CITY OF CONWAY, ARKANSAS HISTORIC DISTRICT COMMISSION

July 22, 2024 • 5:30pm • 1111 Main Street

City of Conway HISTORIC DISTRICT COMMISSION

July 22, 2024

710 Merriman St - Remodel

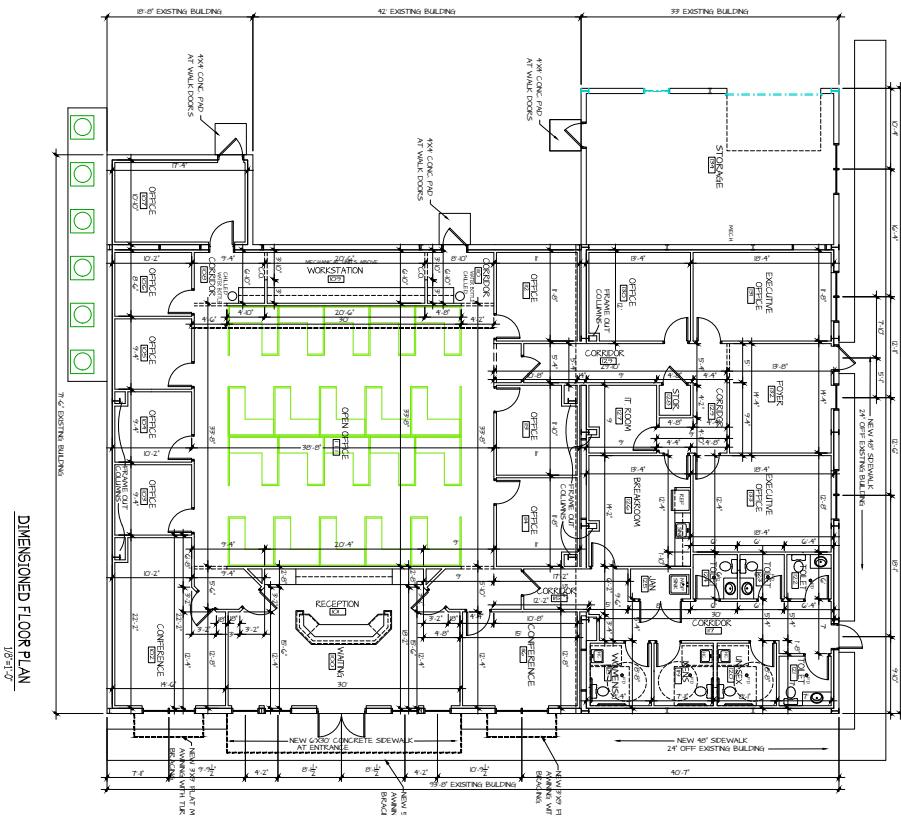
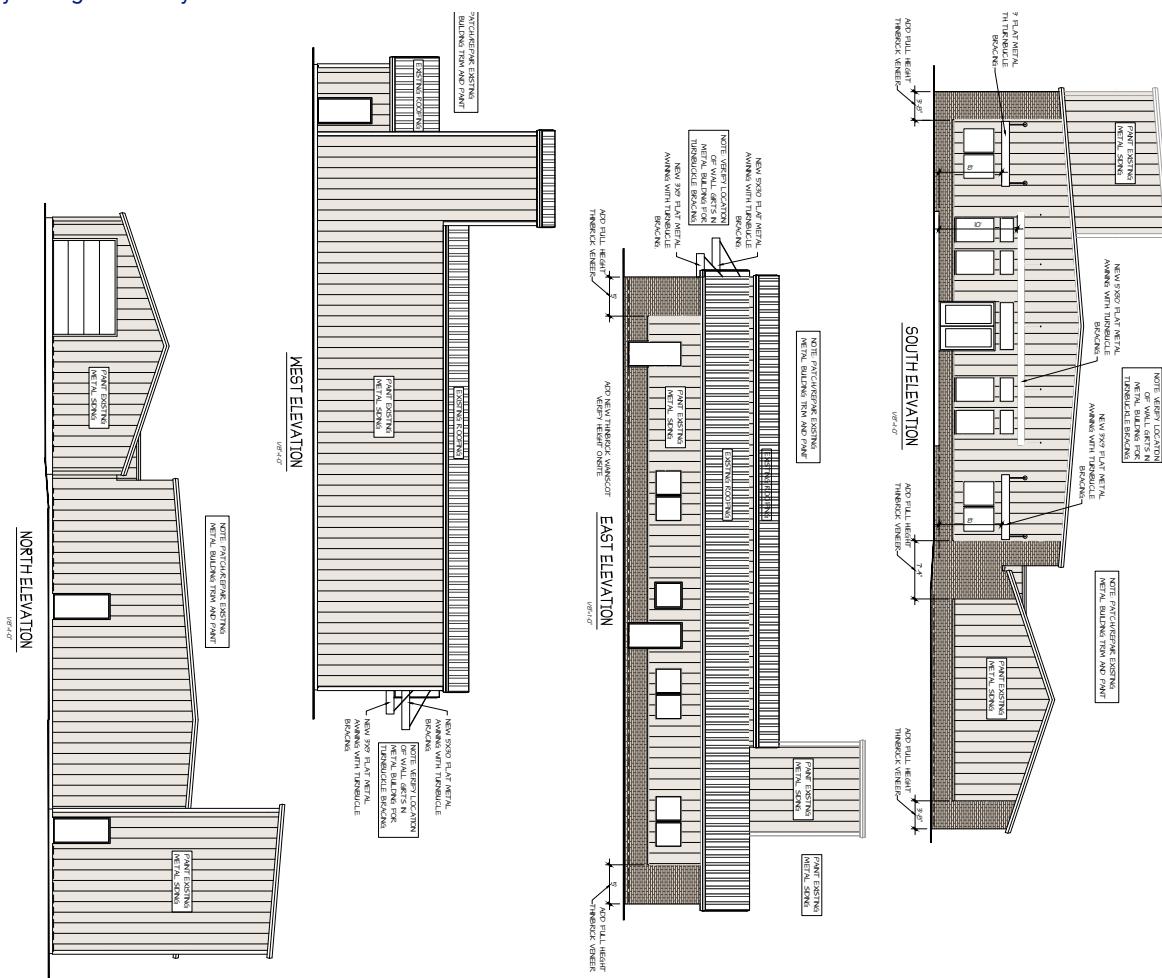
All parking areas will need to be paved. The proposal shows 33 spaces. The proposal is considered over parked per the Conway Zoning Code. The minimum number of parking spaces is 18 and the maximum is 27. The site plan also shows existing parking spaces having continuous access, head-in parking with vehicles backing out onto public streets. Given the existing nature of these head in spaces and the need to meet at least 18 parking spaces, staff recommends removal of the head in parking along Merriman St and the retention of angled parking on Factory St.

Existing chain link fence/razor wire fence will need to be removed and replaced with fencing of permissible material type.

The applicant is proposing to repair metal building trim and paint; add new thinbrick wainscot with full height thinbrick veneer, and metal awnings.

The only unarticulated wall is the western wall which is an existing condition and is interior to the site. Articulation for the other facades is increased by the project.

6. Curb cut may not exceed 24' in width.
7. Prior to issuance of a building permit, the proposal shall undergo Site Development Review which will require the applicant to provide planning staff with a deed showing the property in its current configuration for at least 10 years. If this deed cannot be provided, the property will need to be replatted.

11. Head in parking spaces will need to be removed from Merriman Street frontage and may be changed to angled parking along Factory Street. A minimum of 18 spaces and a maximum of 27 spaces is required for the site.

ARCHITECTURAL SITE PLAN

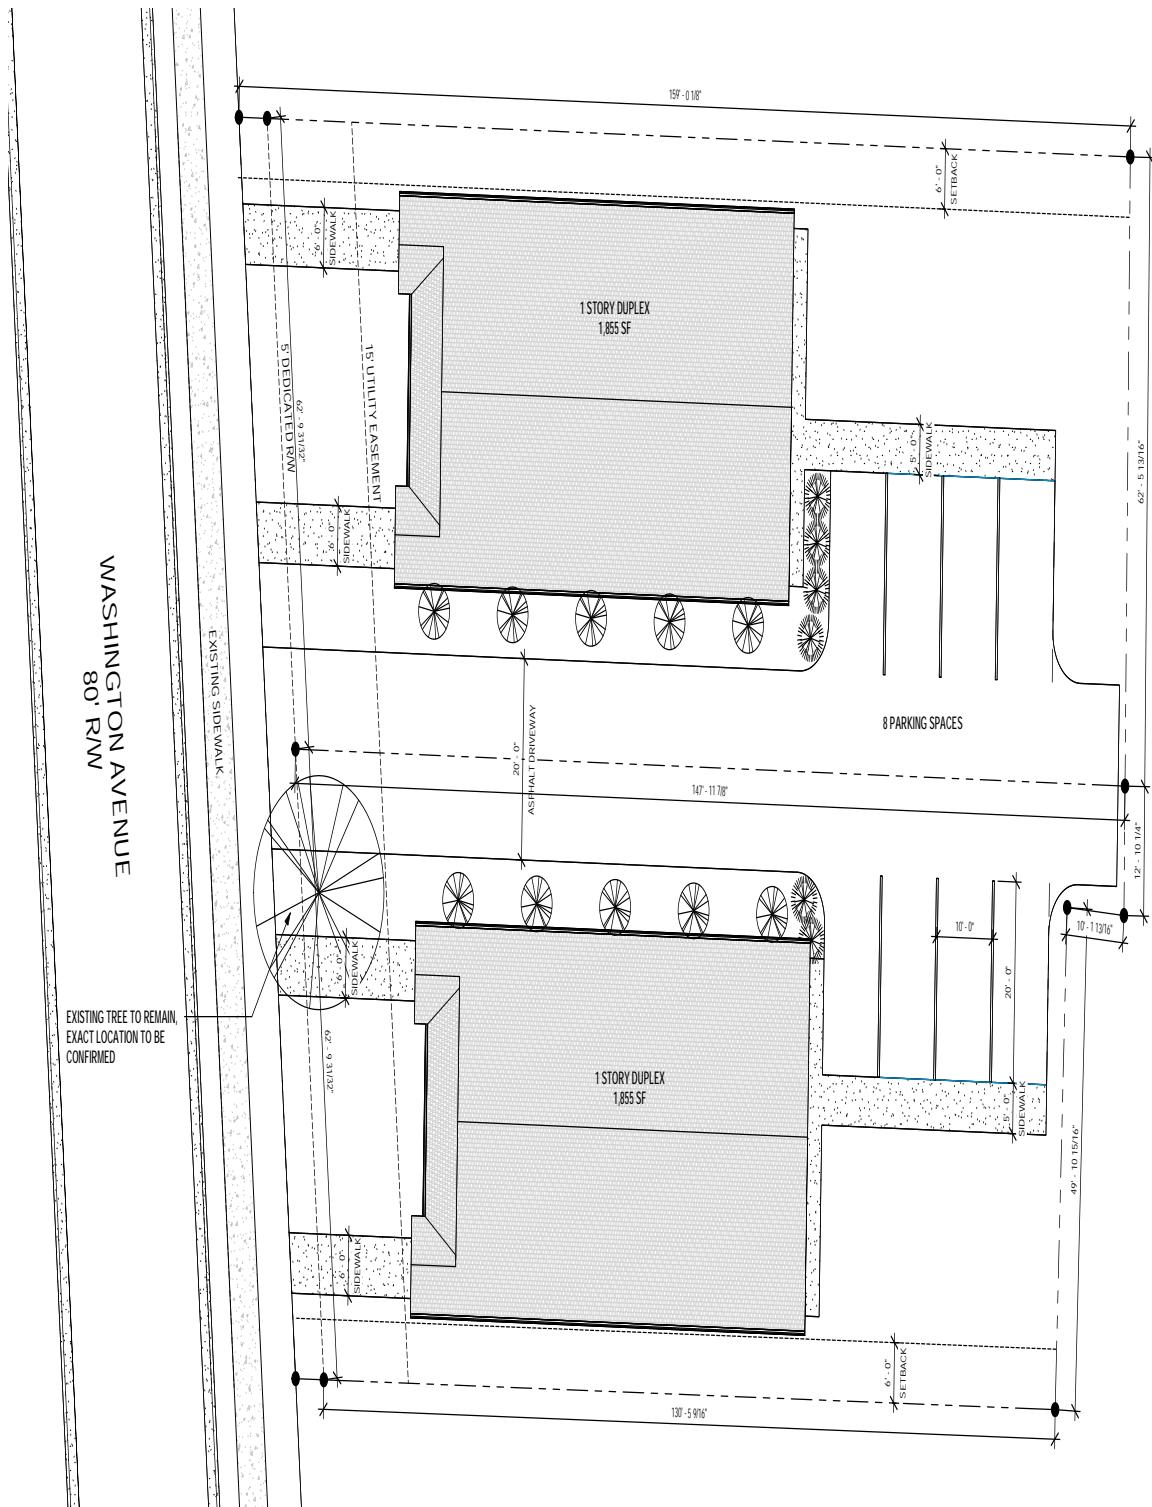
The average front setback for the area is 23', based on five homes in area. The front setback is not clearly called out on the site plan but appears to be 15' and 16' from the right of way. To meet the guidelines, the front setbacks would need to be between 19.5' and 26'. The existing residence on the site has a front setback of approximately 12'. Given the existing conditions, staff can support a setback of less than 85% and 115% of the average in the area.

The applicant has indicated a 20' shared driveway off Washington Ave. The driveway leads to the parking area which consists of four spaces per duplex. The surface material needs to be concrete, pavers or permeable paving. Considering the density of the proposal and its location, staff can support a concrete drive rather than concrete ribbons.

The depth of the porch is not specified but appears to be more than 6' deep. The proposed windows feature wide trim and are three over one. If muntin bars are proposed, they must be true divided lights. Fake muntin bars are prohibited.

8. Prior to issuance of a Certificate of Appropriateness, applicant shall submit for review and approval a site plan showing:

- The front property lines after ROW dedication and the setback between the duplexes and the property lines.

- Depth of front porch.

- Driveway composed of allowed materials.

Front Elevation

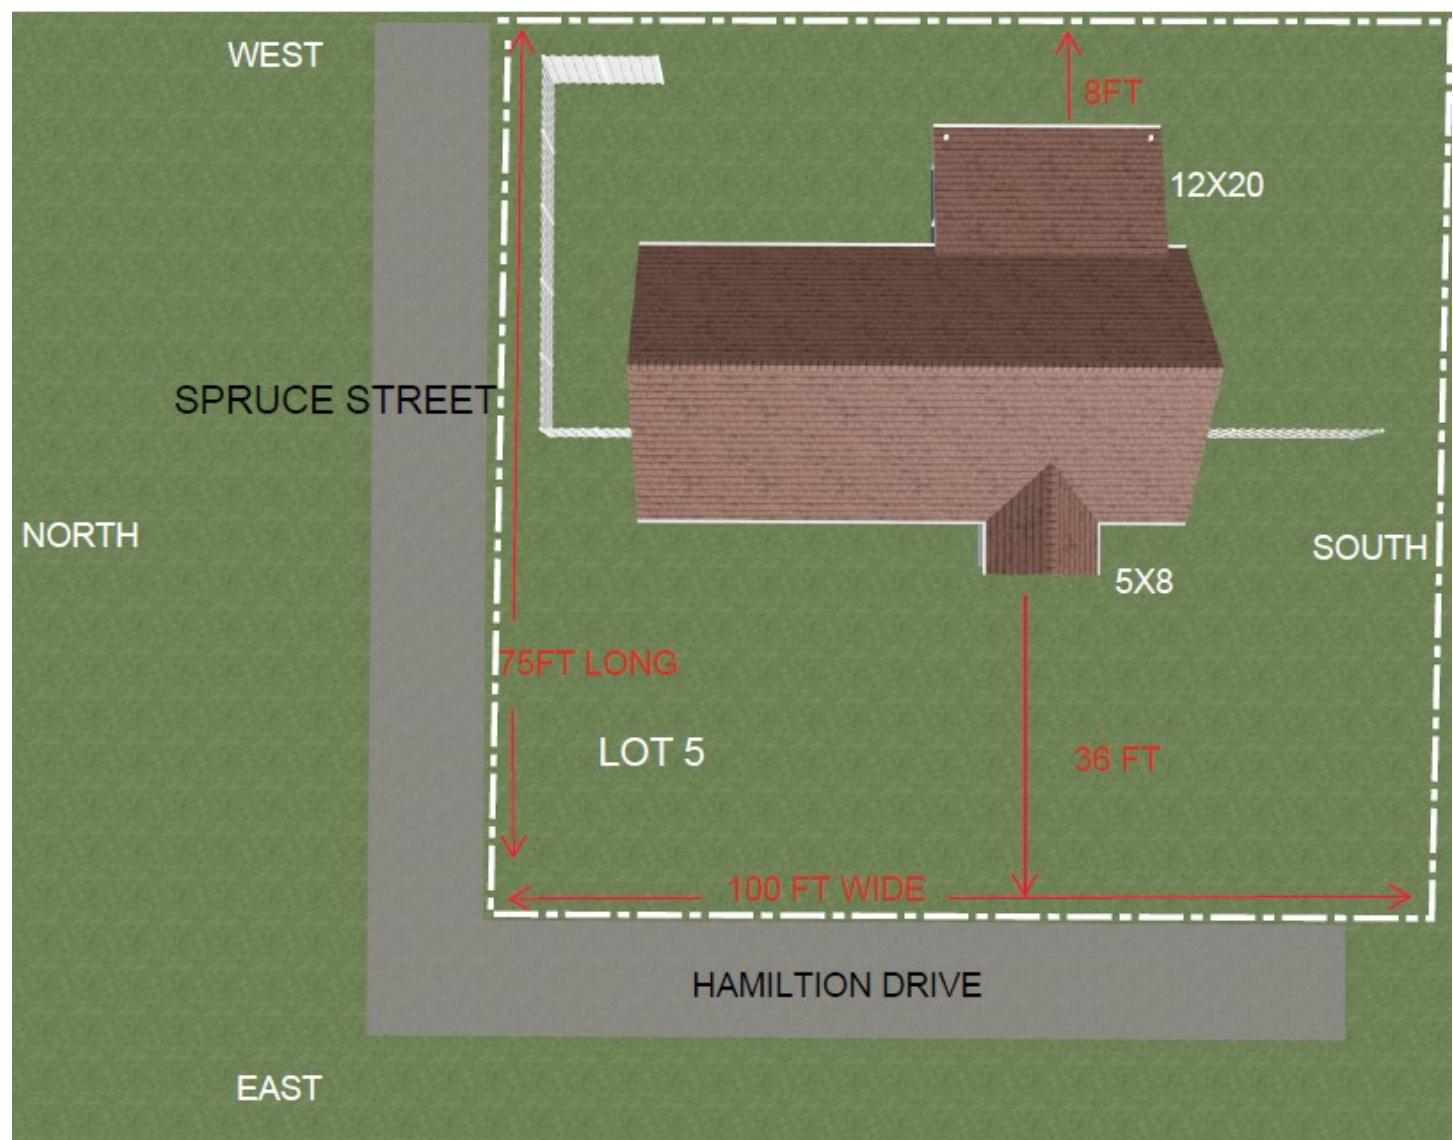
The front porch is greater than 6ft in depth with the entry being enhanced with a gable roof.

No siding is proposed. Porch columns appear to be wood.

Porch roof is a gable with asphalt shingles to match existing.

2. Fencing shall be no more than 3.5 feet tall in front yard along the Hamilton Drive frontage and the secondary front yard along the Spruce St frontage. Pickets may be no more than 4 inches wide and 3 inches apart. Privacy fences shall be no more than 6 feet tall and are only allowed in rear yards. Fence may be constructed of wood, iron, aluminum mimicking iron, or composite wood-like material.

4. Porch roofing shall be asphalt to match existing residence.
